D350-822-011
Job Sheet 189906

Part Name: PA100 PUREair System for AS350/EC130

DART SERVICE INSTRUCTION

TO AMEND INSTALLATION INSTRUCTIONS IIN-D350-822 REV. H AND INSTRUCTIONS FOR CONTINUED AIRWORTHINESS ICA-D350-822 REV. 6 OR LATER APPROVED REVISION

Figure 1 - QB21308 Assembly Screen

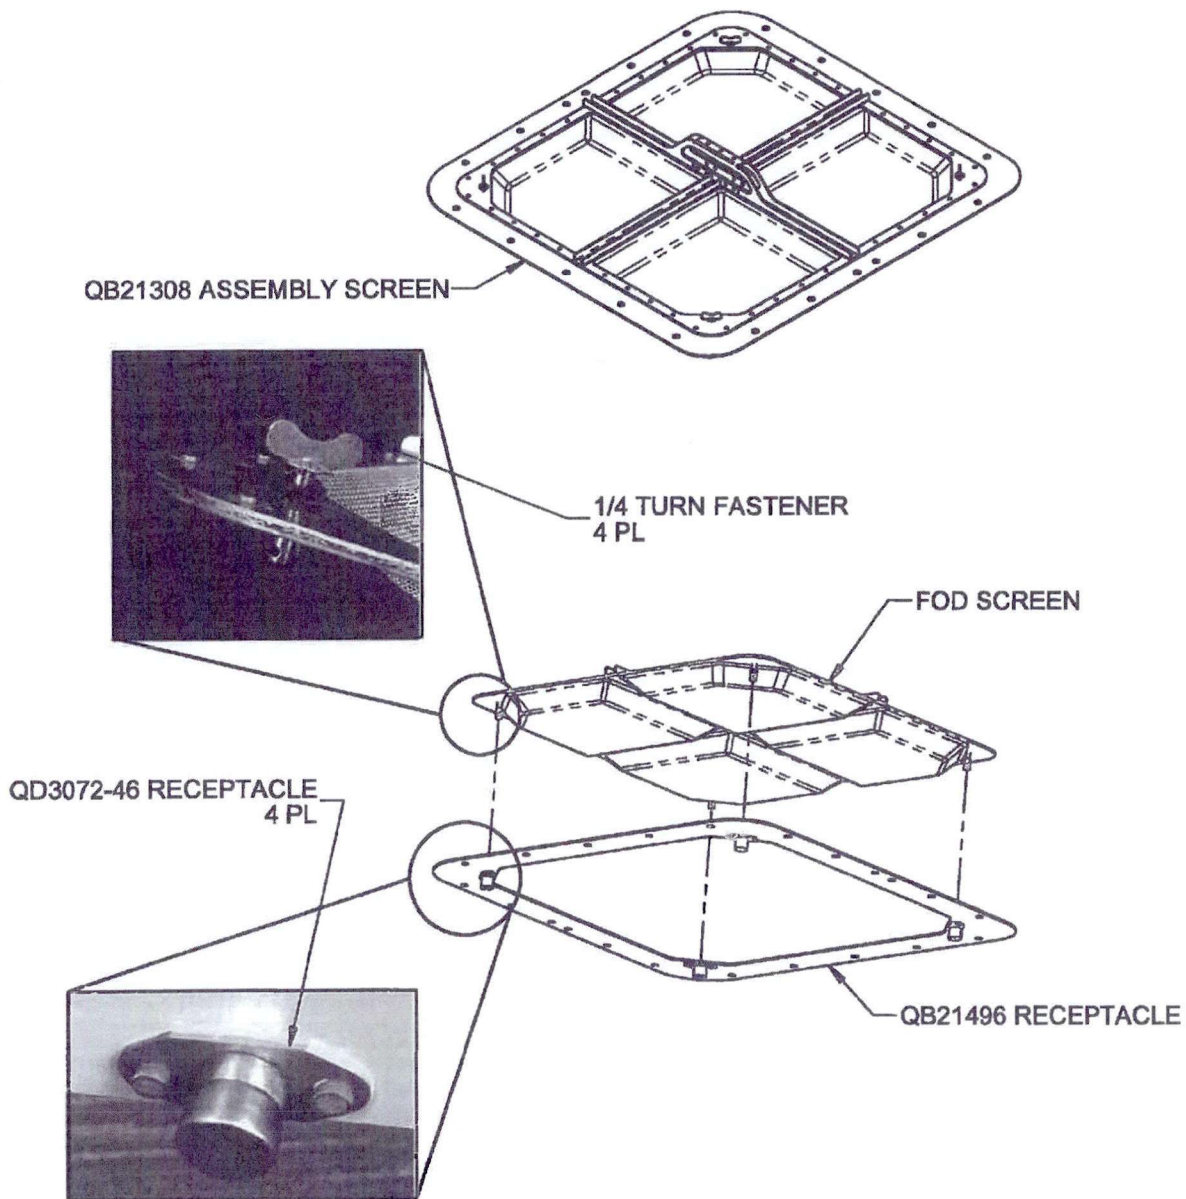
- 2.1.3 Separate the FOD screen from the QB21496 Receptacle by turning the 1/4 turn fasteners and lift the FOD screen per Figure 1.
 - 2.1.4 Drill out the retaining rivets and remove qty(4) QD3072-46 Receptacles from the QB21496 Receptacle. Remove any adhesive residue.

- NOTE: Although not generally necessary, it is acceptable to use longer or shorter MS20426AD3-X Rivets
- 2.1.8 Remove qty(4) 1/4 Turn Fasteners from the FOD Screen per Figure 1.

Figure 2 - DSI 9815-011 Replacement Receptacle Kit

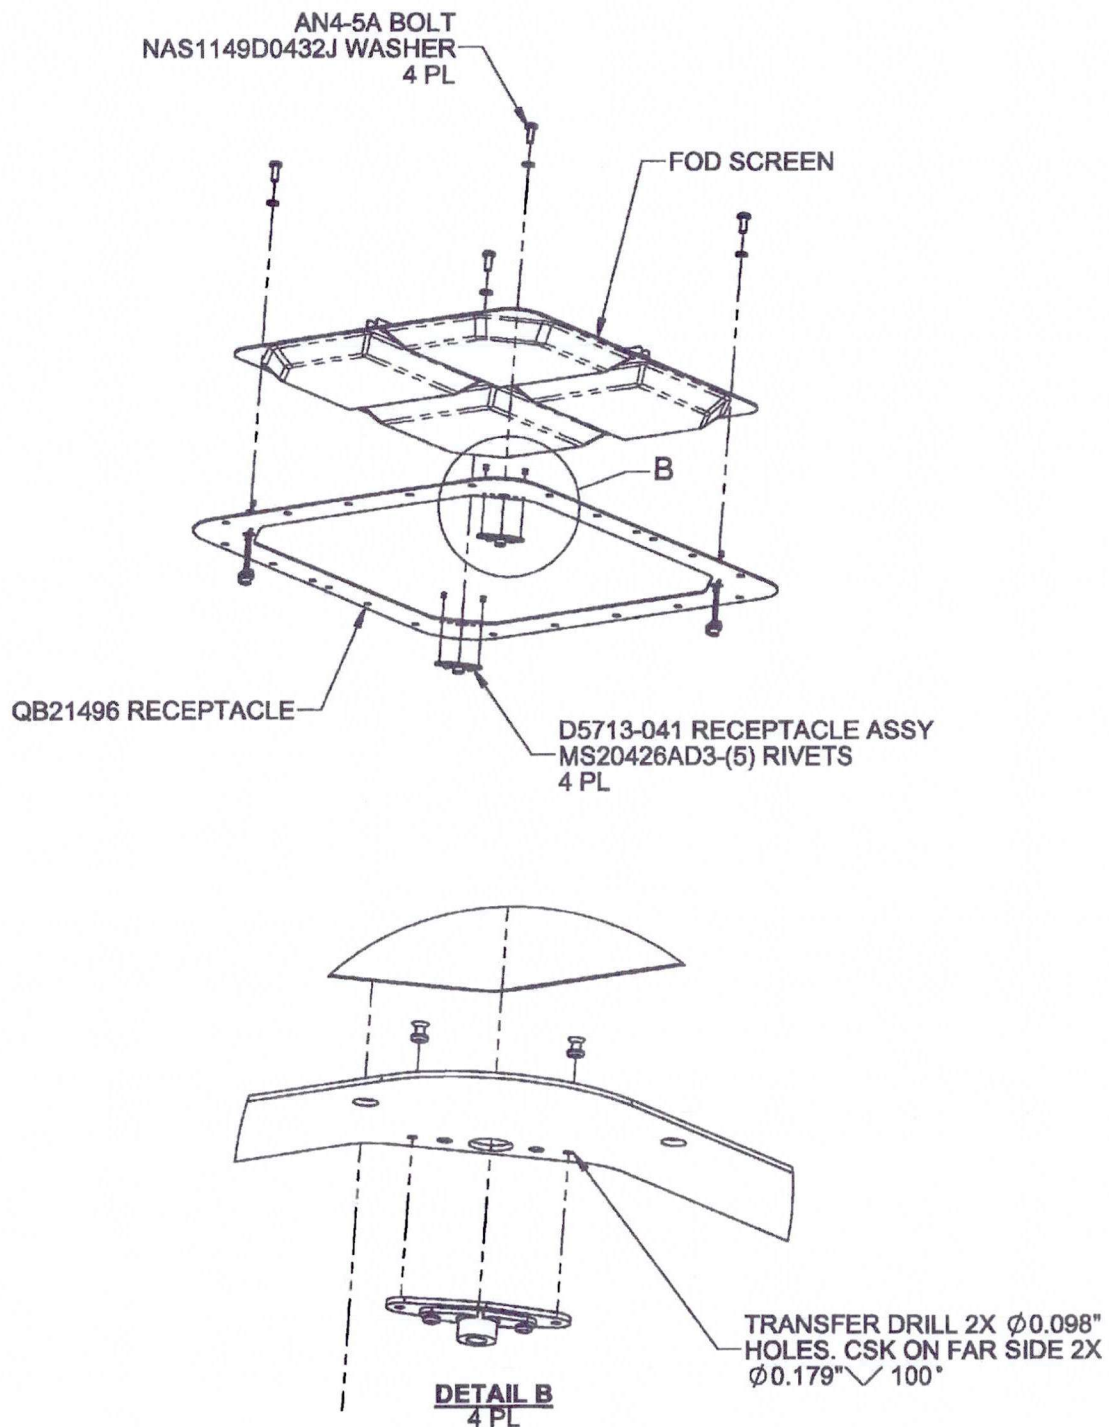
- 2.1.5 Position the qty(4) D5713-041 Receptacle Assy in the location shown in Figure 2. Transfer drill 2x $\phi 0.098$ " holes with CSK $\phi 0.179$ " $\angle 100^\circ$ on the top side from the D5713-041 Receptacle Assy to the QB21496 Receptacle. Touch up holes with Alodine 1200 per MIL-C-5541.

- 2.1.6 Mask nutplate holes and touch up the affected areas with prime and paint per ICA-D350-822.
 - 2.1.7 Install qty(4) D5713-041 Receptacle Assy with qty(2) MS20426AD3-(5) Rivets per Figure 2.

- 2.1.9 Reinstall the FOD screen on the QB21496 Receptacle using qty(4) AN4-5A bolts and qty(4) NAS1149D0432J Washers per Figure 2. Torque bolts to 50-70 in-lb (5.6-7.9 N-m).
